**MEMORANDUM**

**DATE:** August 18, 2014  
**TO:** John Wallace – UW  
**FROM:** Tom Mergy - PBS  
**PROJECT NO:** 40035.590  
**RE:** **UW 203512 - Maple Terry Hall –PCB Cleanup Response Comments**

At your request, PBS Engineering & Environmental, Inc. (PBS) is providing a response to the EPA Comments regarding the PCB Soil Cleanup under Terry Hall, from Michelle Mullin, PCB Coordinator US EPA Region 10 dated Wednesday, July 30, 2014

PCB EXCAVATION SAMPLE LOCATIONS

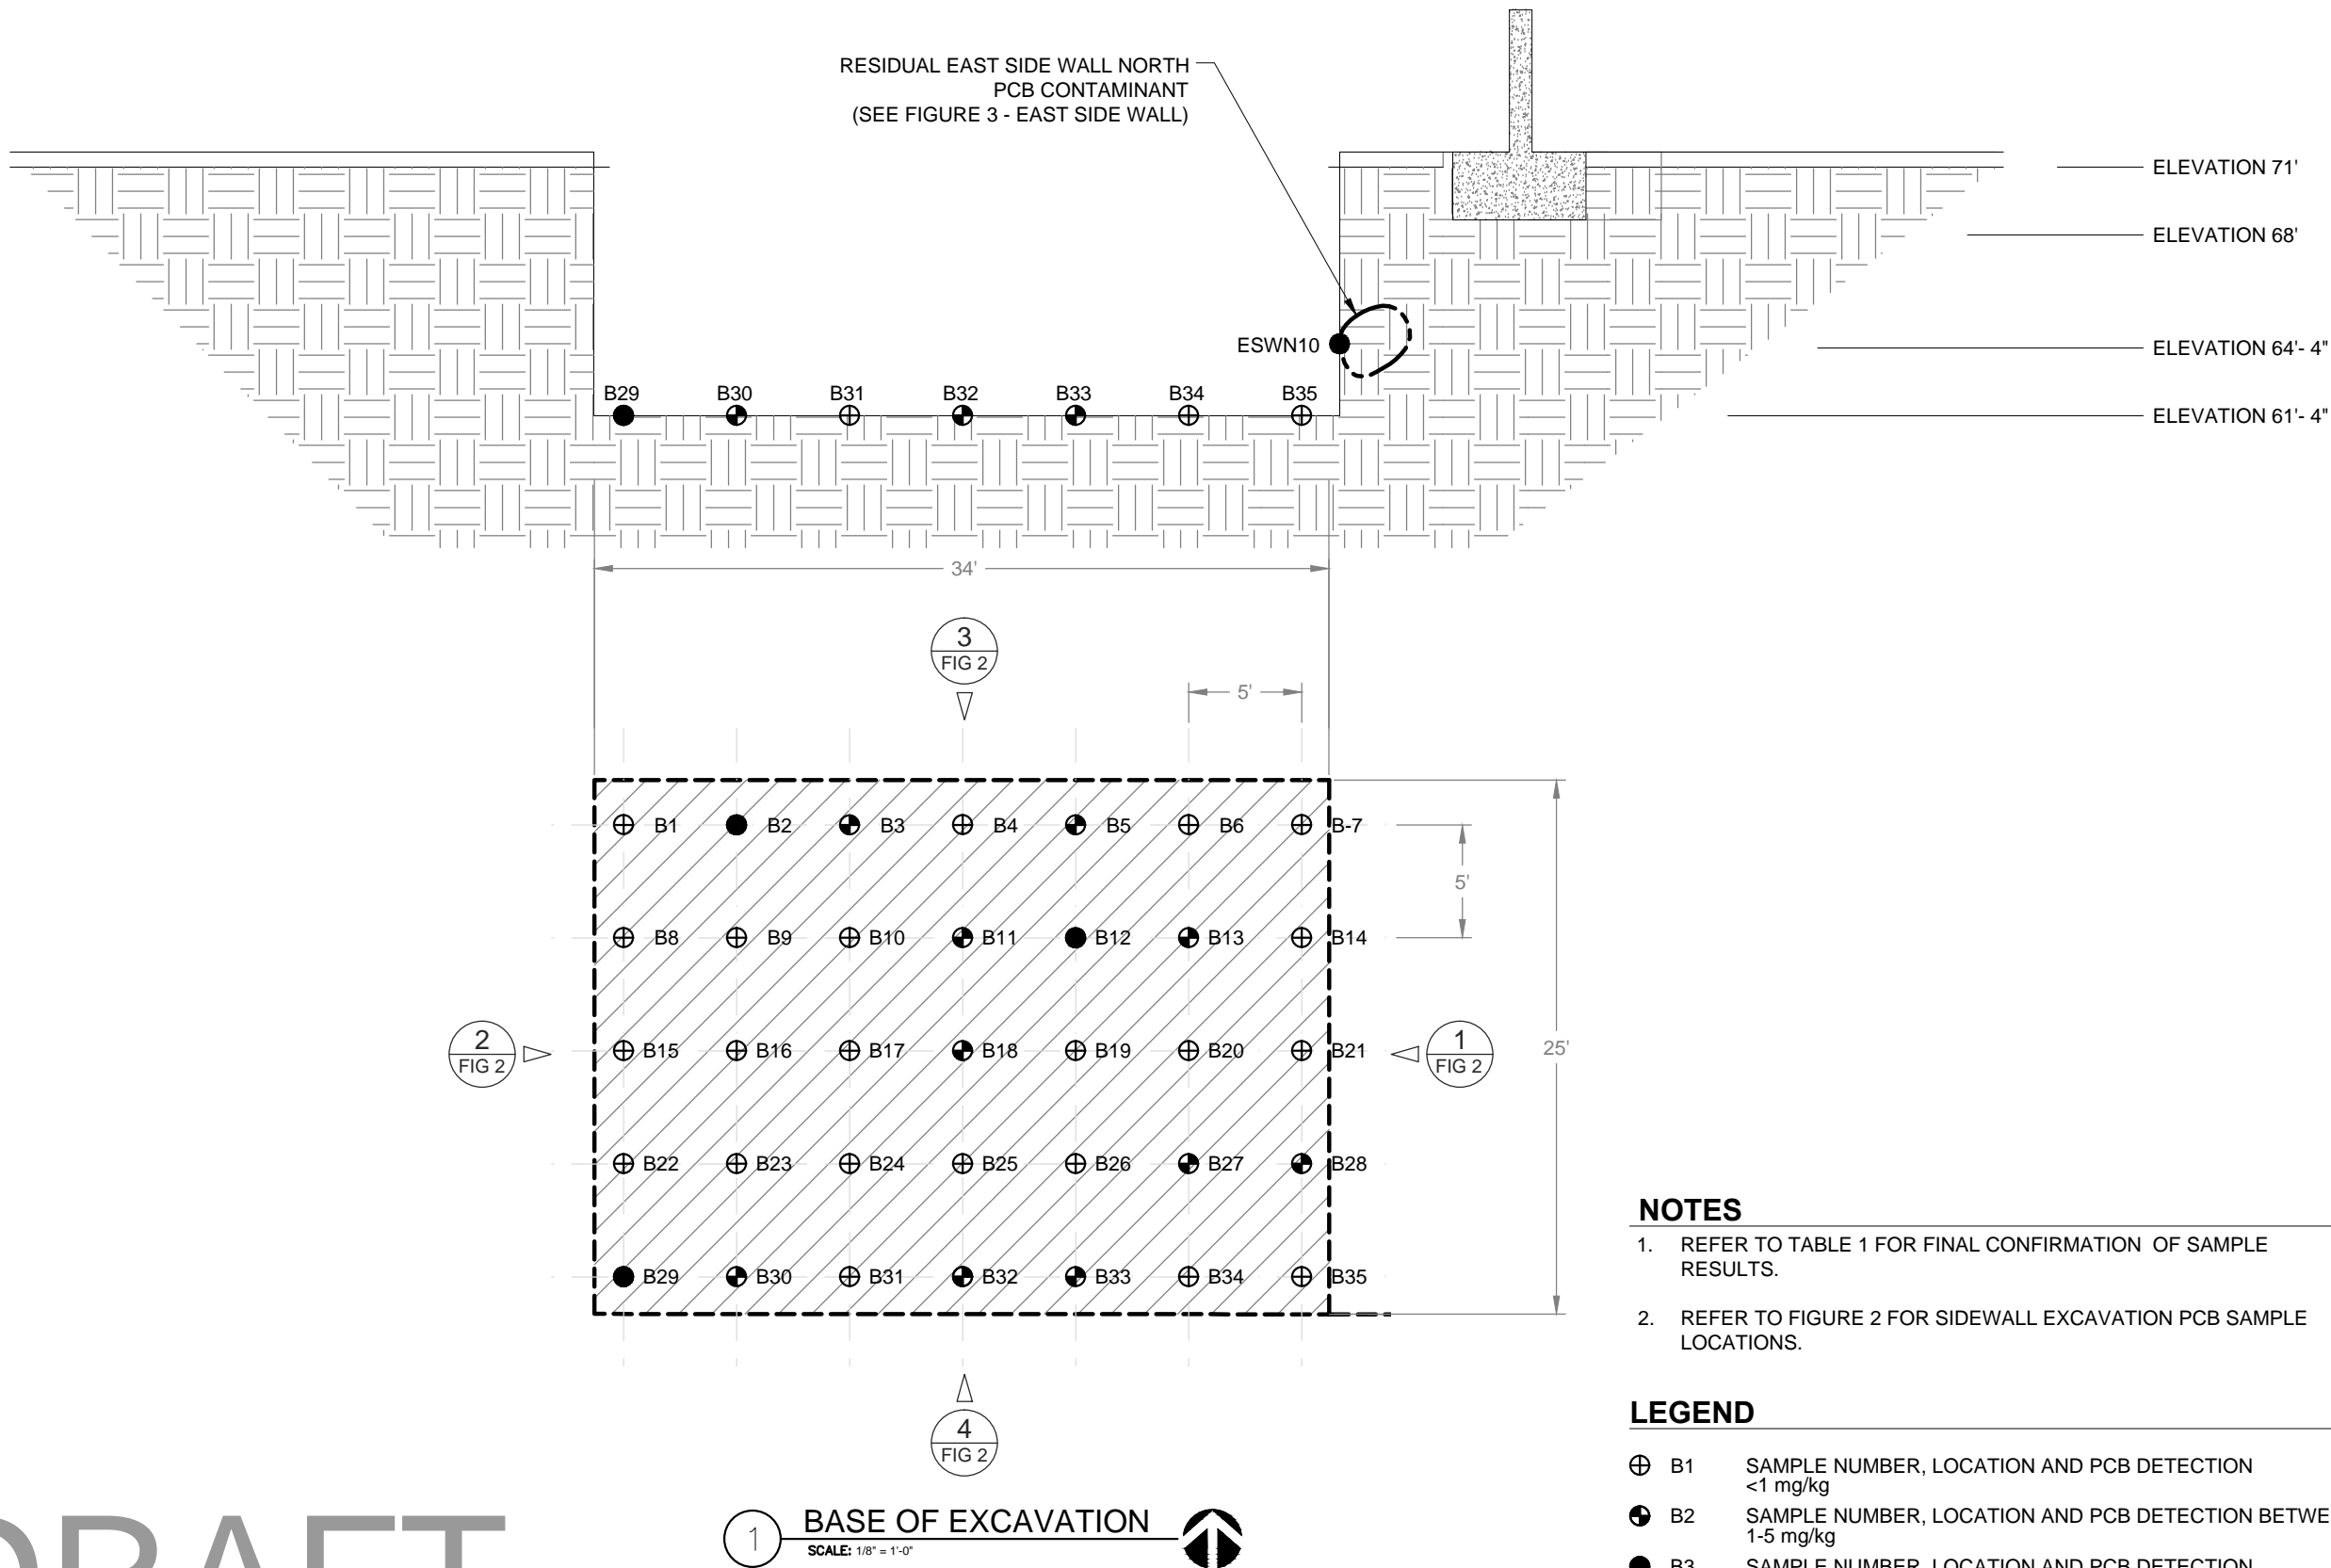
1. Can you provide the figures that show the sample locations and PCB results?

*Figures 2 and 3, as contained in the PCB Summary Report, June 6, 2014, display the sample locations. Table 1 summarizes the lab results and corresponds to sample locations/IDs presented on Figures 2 and 3. PBS will draft an additional figure (fig 4) that will show relationship of the PCB excavation in relation to the Terry Hall foundation plan.*
